BART Seismic Retrofit Project

Berkeley Hills Tunnel to the Montgomery Street Station

ENVIRONMENTAL ASSESSMENT

Response to Comments

Figure 1. Barge Anchoring Layout and Profile for Vibro-Replacement at the San Francisco End

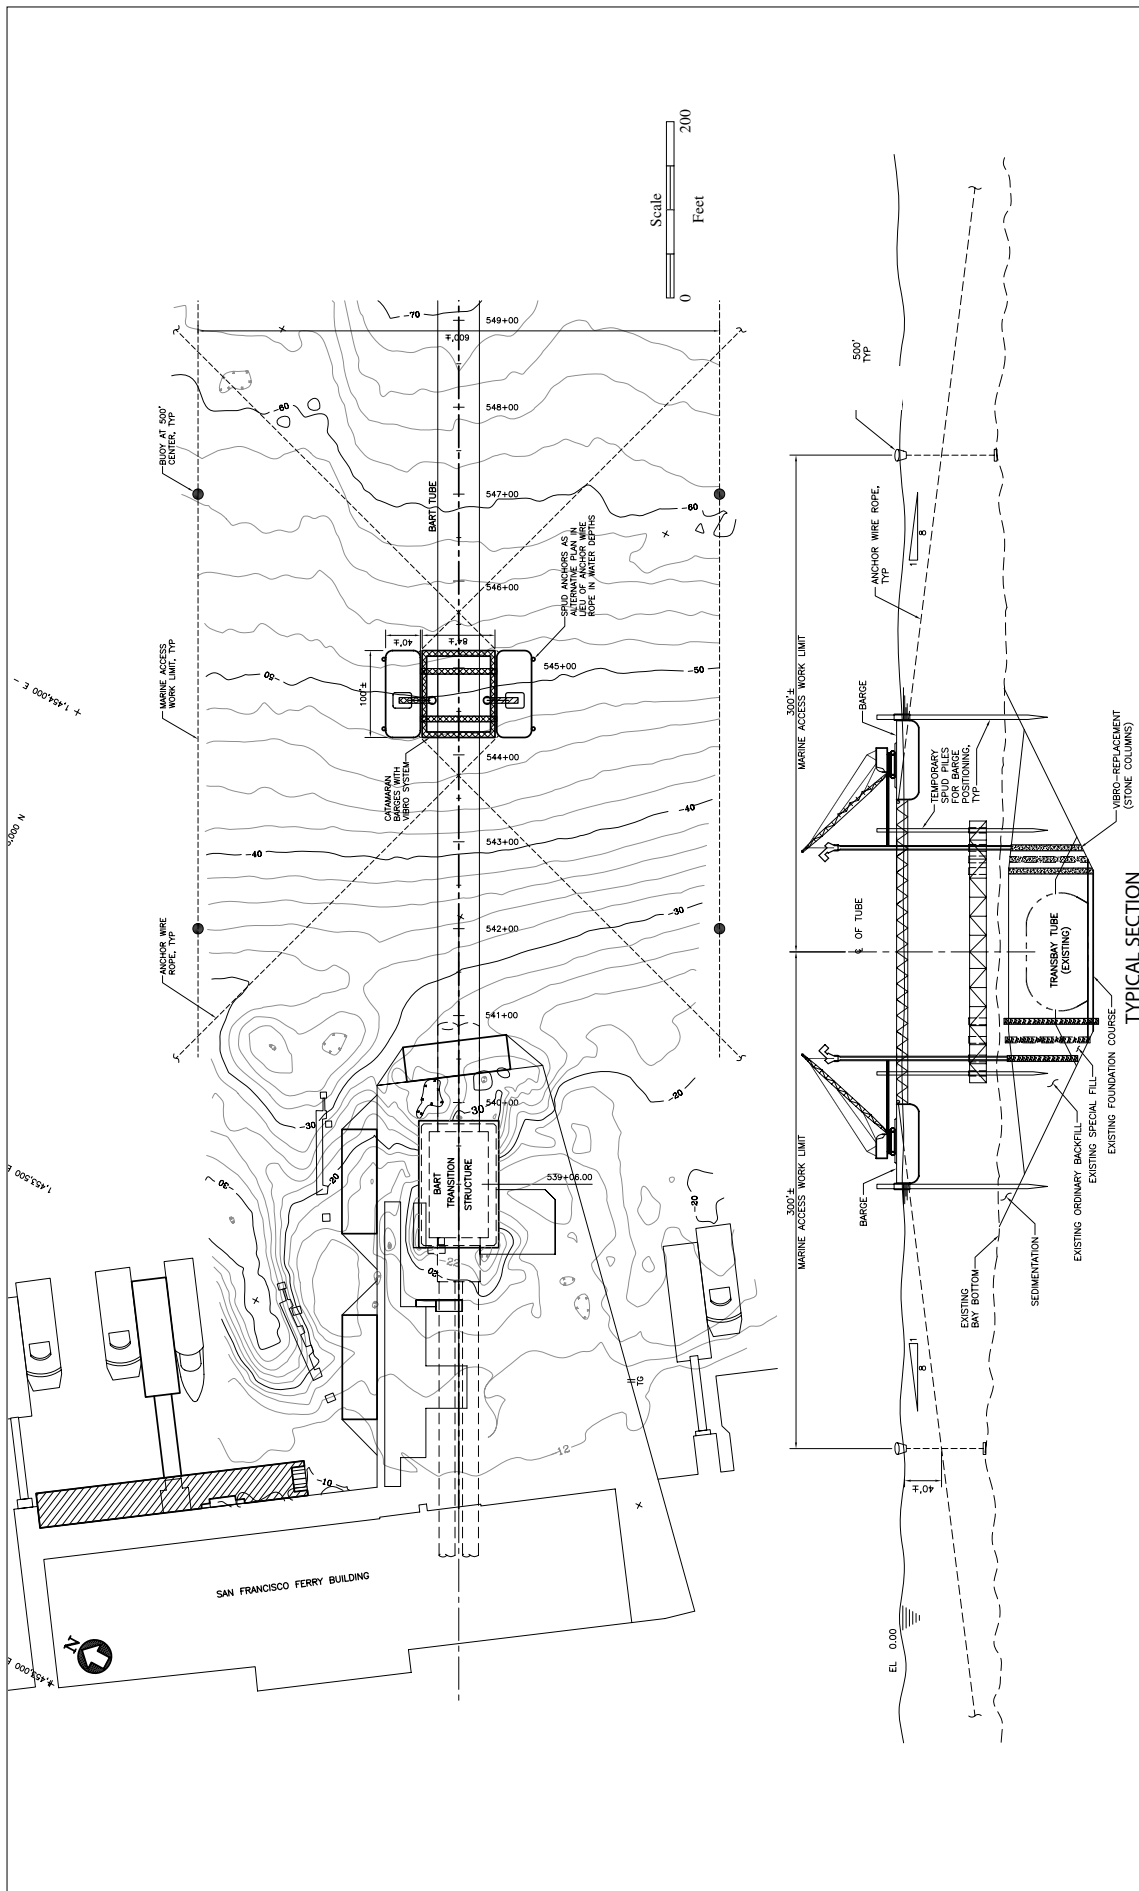
Figure 1, below, depicts the full of extent of barge work areas in plan view within the vicinity of the San Francisco Ferry Plaza Platform (Platform), and clarifies EA Figure 2-3 depicting proposed vibro-replacement activities at the San Francisco end of the Tube. As indicated in Figure 1, spud anchors would be used in water depths up to 50 feet in lieu of anchor wire rope to avoid interfering with ferry movement. Therefore, project construction activities associated with vibro-replacement will not interfere with ferry operations in the vicinity of the San Francisco Ferry Terminal.

Figure 2. San Francisco Transition Structure Construction Phase 0

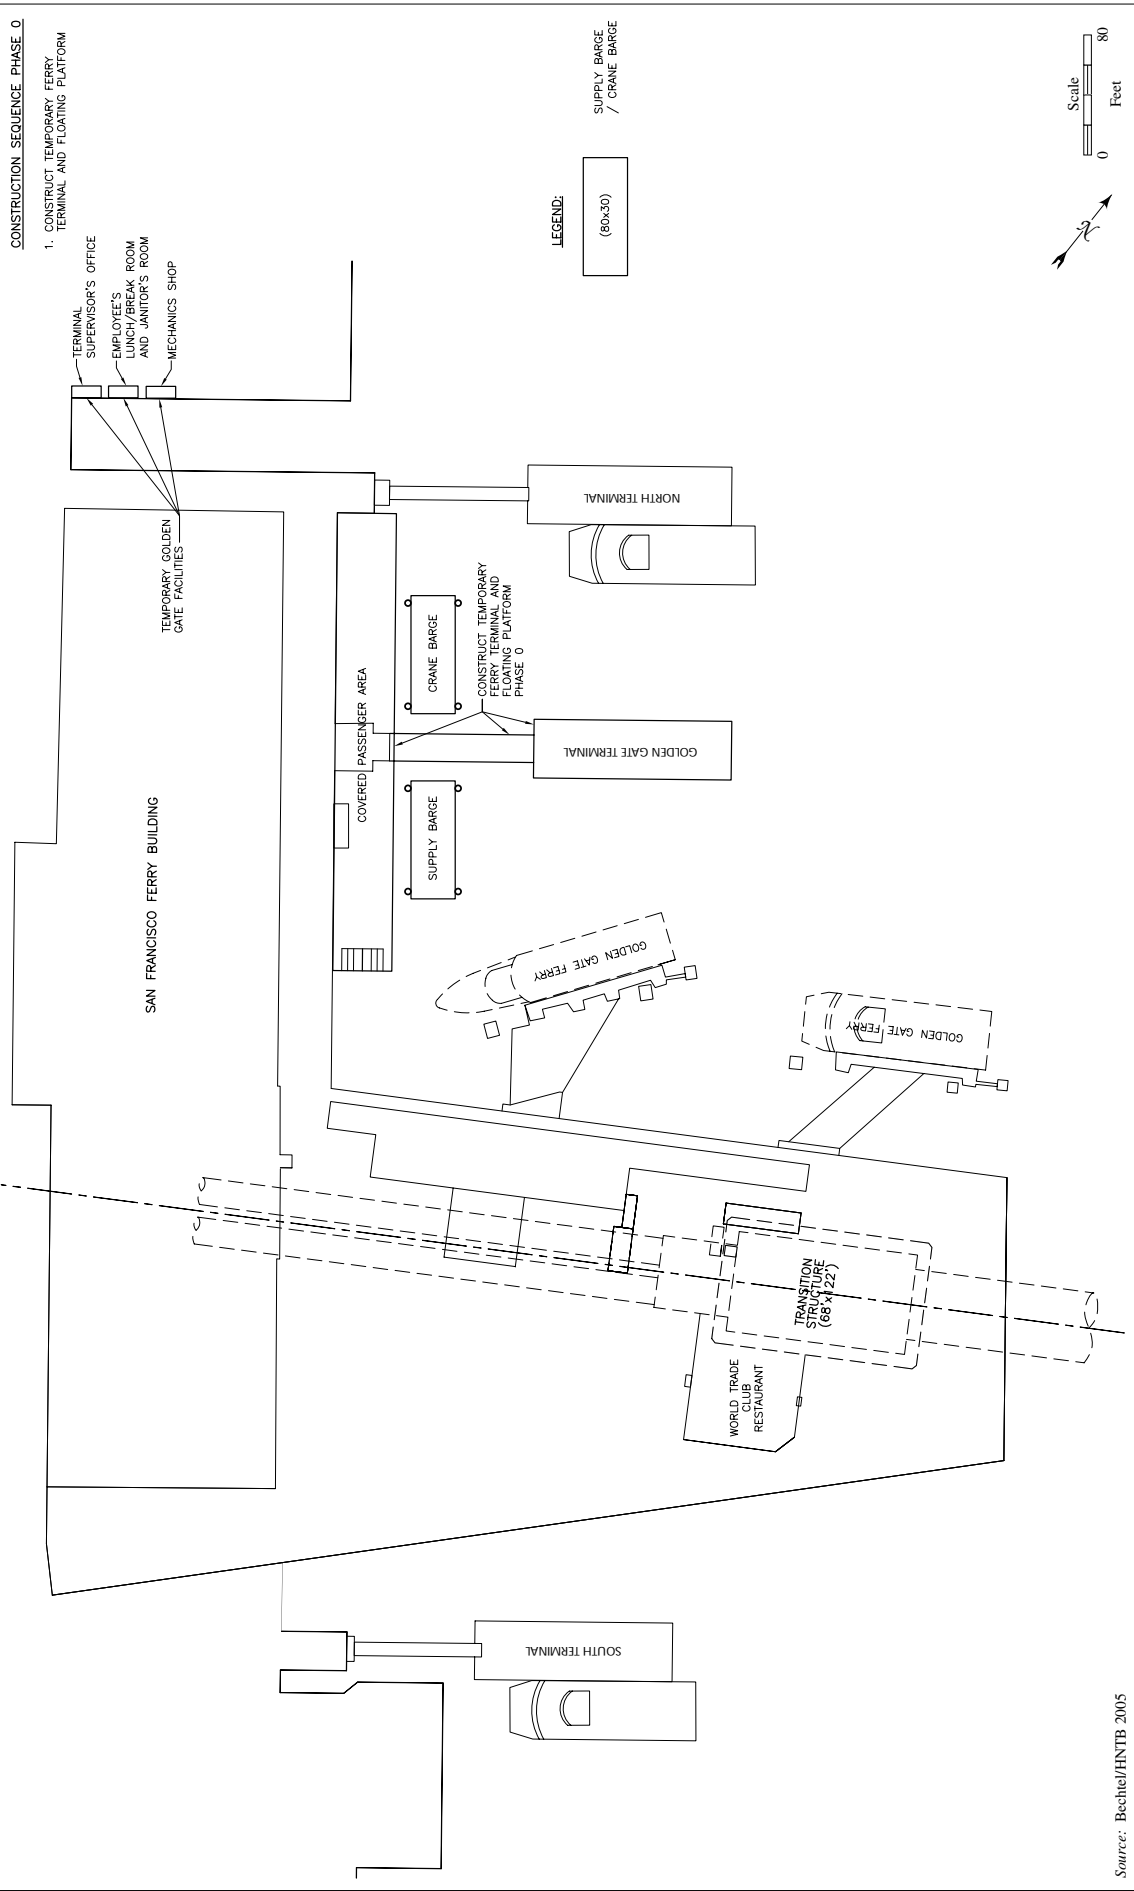
1 The marine-based construction option (Construction Method 1) at the Platform, described on EA
2 page 2-24, lines 6-19, has also been removed from consideration. Accordingly, the plaza-based
3 construction method (Construction Method 2), in which construction equipment would be placed
4 directly on top of the Platform, would be implemented. Details of the construction sequence
5 associated with this method are described below, and are depicted in Figures 2 through 7.

6 To facilitate access to and use of the Platform for retrofits at the transition structure, construction
7 would occur in up to six phases. This would allow portions of the Platform to remain publicly
8 accessible throughout the duration of construction, and would allow portions of the Platform to be
9 reconstructed immediately following completion of certain retrofit activities, and before the
10 beginning of others. The total platform area is 108,000 sf, and the maximum area of the Platform to
11 be removed and replaced is approximately 59,000 sf, (approximately 55 percent of the total Platform
12 area). However, the maximum Platform area that would be restricted from physical public access
13 during any of the construction phases would be 39,000 sf, which represents approximately 36
14 percent of the total platform area.

Figure 3. San Francisco Transition Structure Construction Phase 1

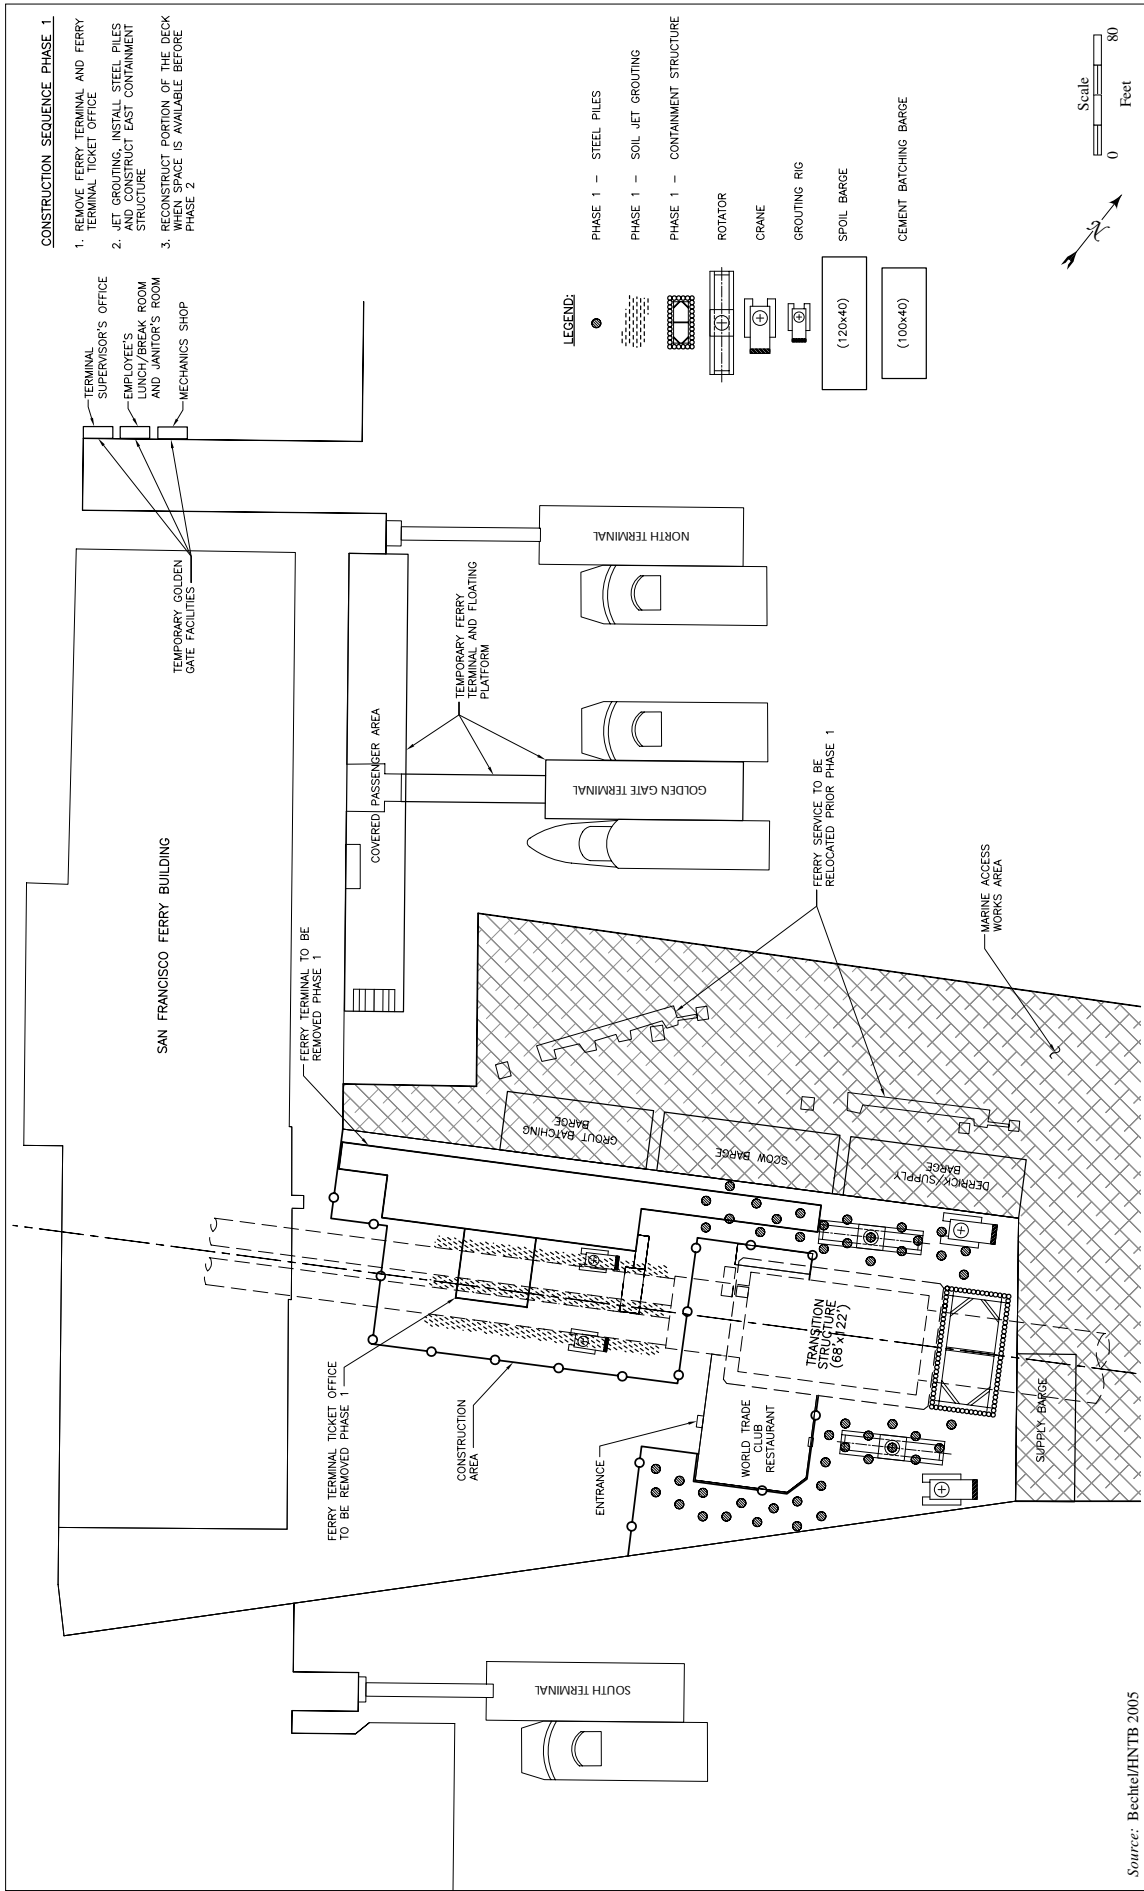
7 As part of Phase 1 construction, the approximately 13,300 sf Golden Gate Ferry Terminal and
8 Ticket Office would be removed. Implementation of soil jet grouting around the Tube below mud
9 line, installation of up to 48 steel pipe piles associated with the Pile Array, and construction of the
10 east end containment structure would occur during this phase (see Figure 3). Activities associated
11 with Phase 1 would require closure of up to 39,000 sf of public access area on the Platform to
12 accommodate the construction equipment, including cranes, rotators, grouting rigs, and
13 construction supply barges. Reconstruction of a portion of the Platform when space is made
14 available would occur before the beginning of Phase 2 construction activities. The anticipated
15 construction area and the marine access work area are depicted on Figure 3.

Figure 4. San Francisco Transition Structure Construction Phase 2

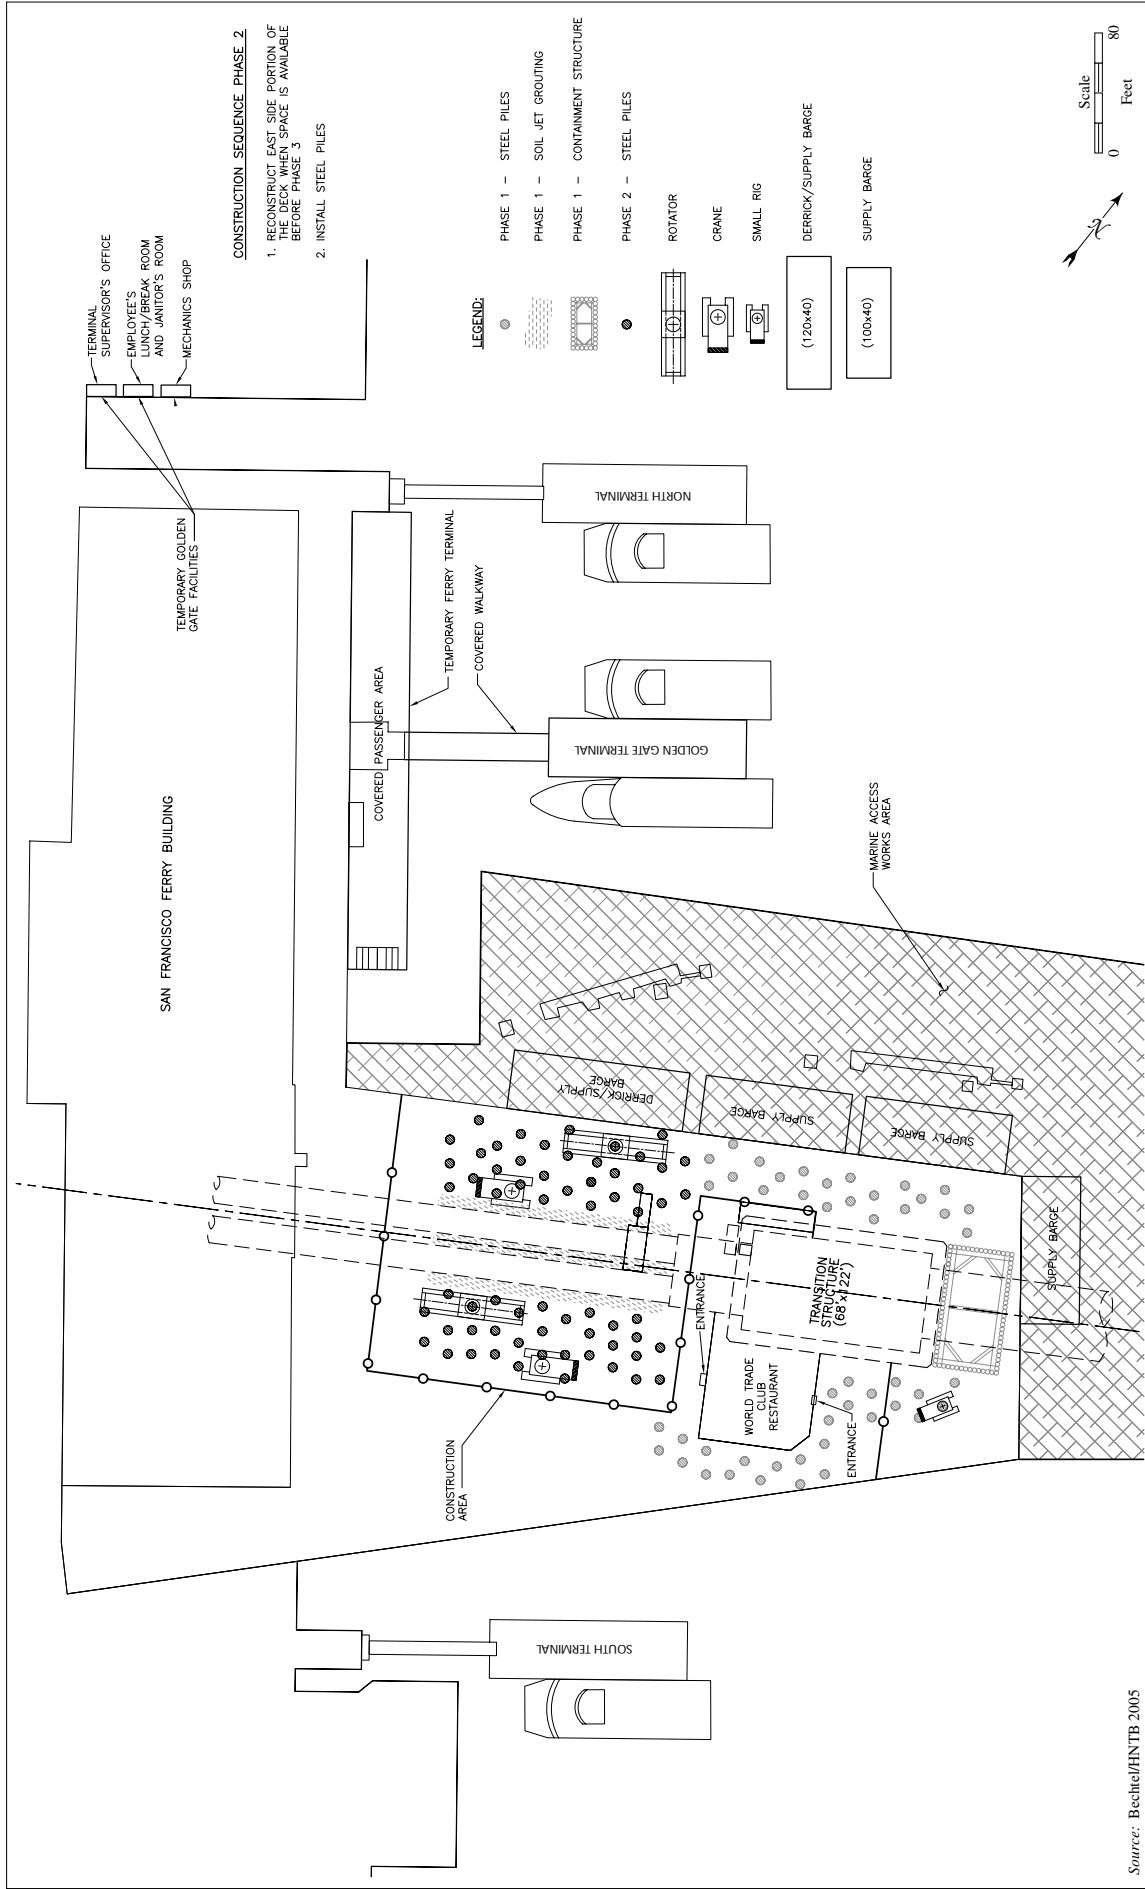
16 Phase 2 construction would include installation of up to 64 steel pipe piles associated with the Pile
17 Array, and would affect a smaller portion of the Platform compared to the Phase I construction
18 area (see Figure 4). Closure of public access areas would be required to accommodate the
19 construction equipment, including cranes, rotators, small rigs, and construction supply barges.
20 Reconstruction of the eastern portion of the Platform when space is made available would occur
21 before the beginning of Phase 3 construction activities. The anticipated construction area and the
22 marine access work area are depicted on Figure 4.
